Please revise report based on  
Soils and Geology Report  
Checklist that will be uploaded  
seperately

## Geotechnical Engineering Report

Meridian Circle K Retail Store

PCD File VR-22-03

# EXPLORATION PLAN

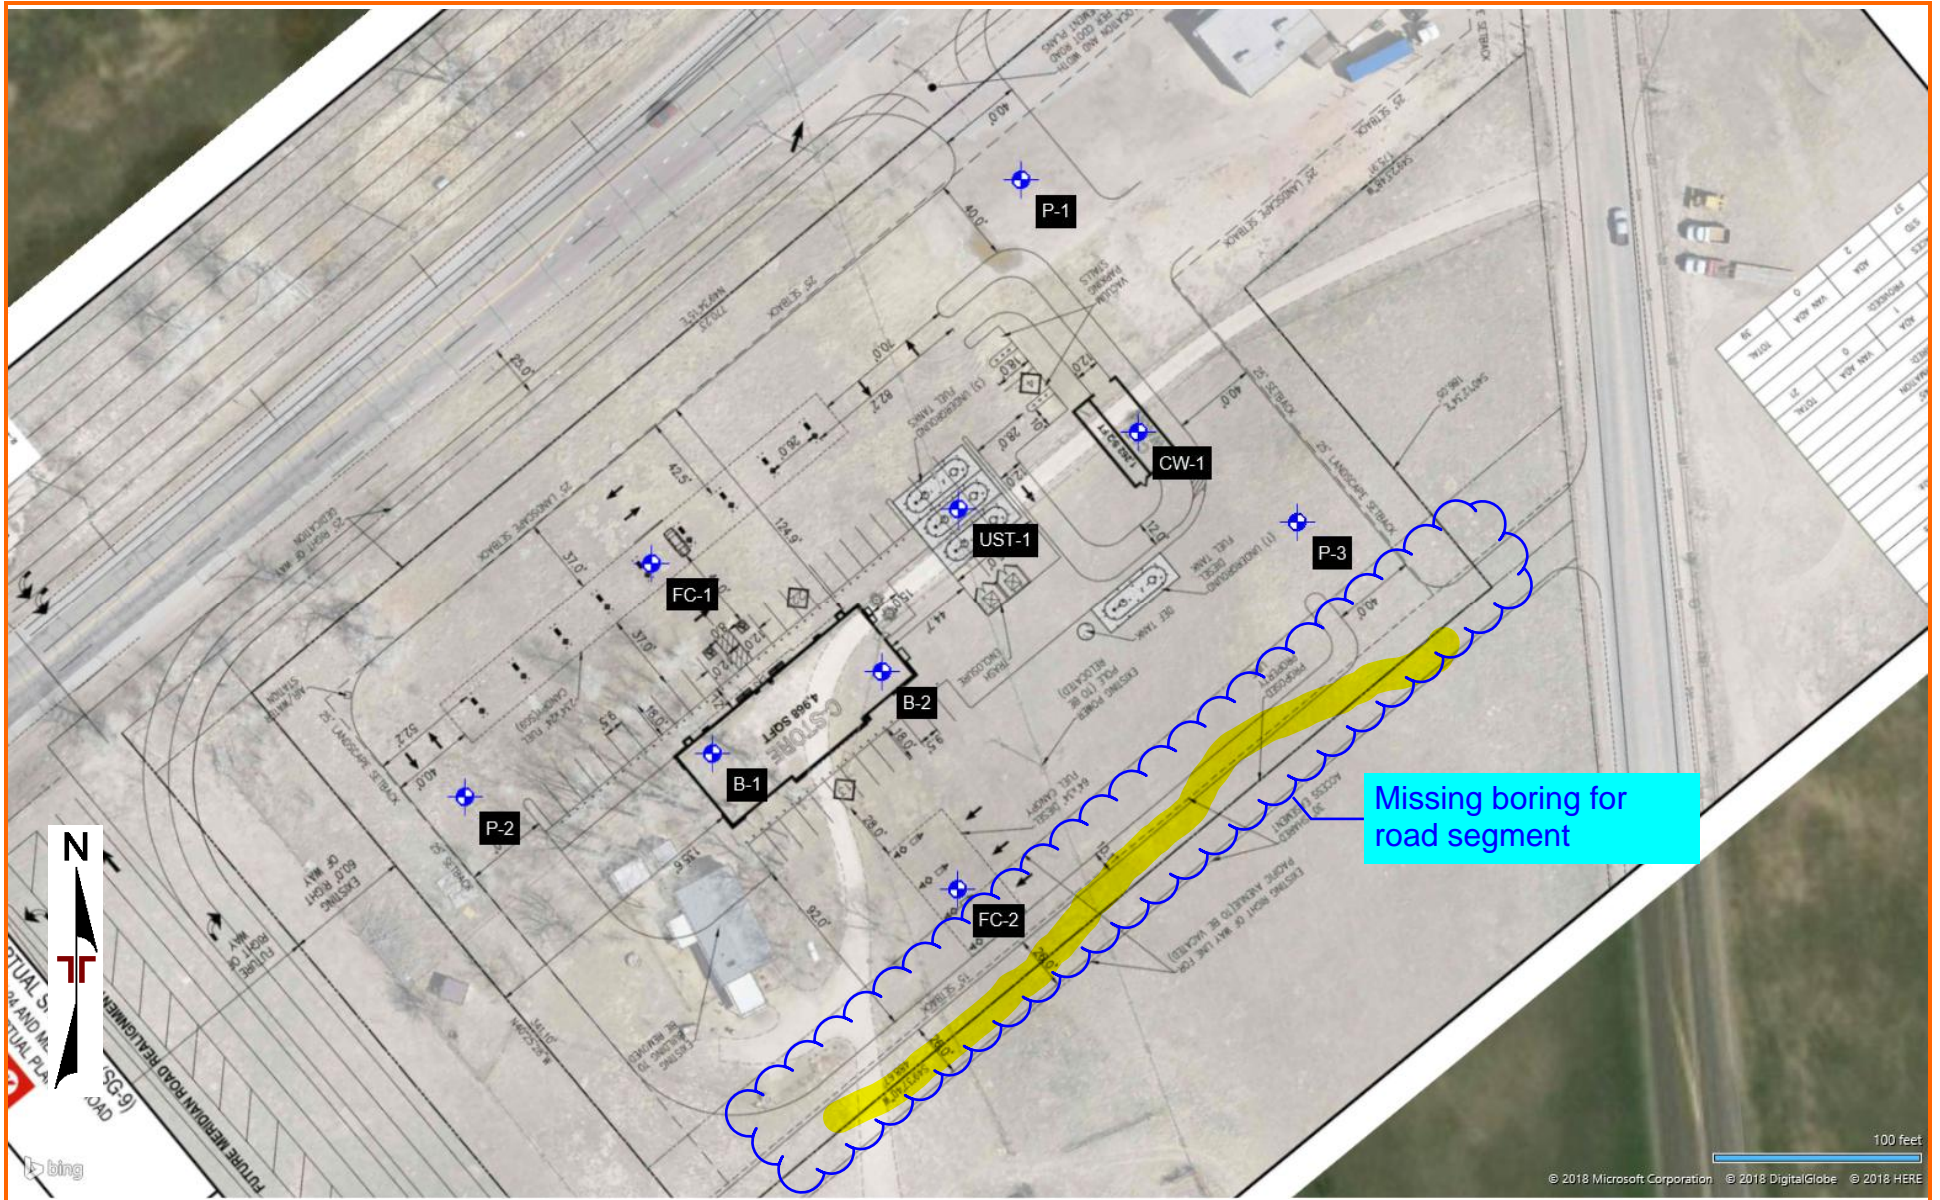
See notes below concerning borings

A. Timing of Soil Borings. 1. Initial Borings. The information from the initial soil borings shall be summarized in the Geotechnical Report. The entire site shall be sampled for initial testing. This is required to evaluate soil and groundwater conditions and for evaluating roadway locations that may not yet be determined or may change. 2. Structures. Soil borings for design of transportation structures shall be taken prior to the design of the structure. 3. Fill for Right-of-Way Grading. Testing shall be provided for all proposed fill material. All proposed fill material shall be approved by The ECM Administrator prior to placement. The material shall meet minimum requirements and be equal to or better than existing conditions. No fill material with a liquid limit greater than 40 and plasticity index greater than 20 shall be used in the upper 2-feet of the pavement subbase without implementing proper mitigation techniques.
